**Japan Feedbacks against EC/US/UK proposal
on
Part A and Part B program**

Revision_1
10th September, 2021

52nd EVE IWG Meeting
8th and 10th September, 2021

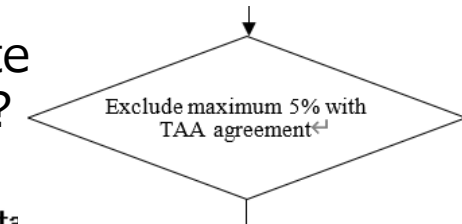
- J** JPN Counter-proposal
Last charged band for more than 50% of nominal capacity
eg. SOC after charged – SOC before charge > 50 %
- DP** DILARA Panagiota (GROW) 2021年7月09日
To be decided. It has implication of having to set codes.
- J** JPN_20210910 4 分前
JPN needs to know how this on-board value works.
It's just up to OEM ?
or plan to define the concrete criteria ?
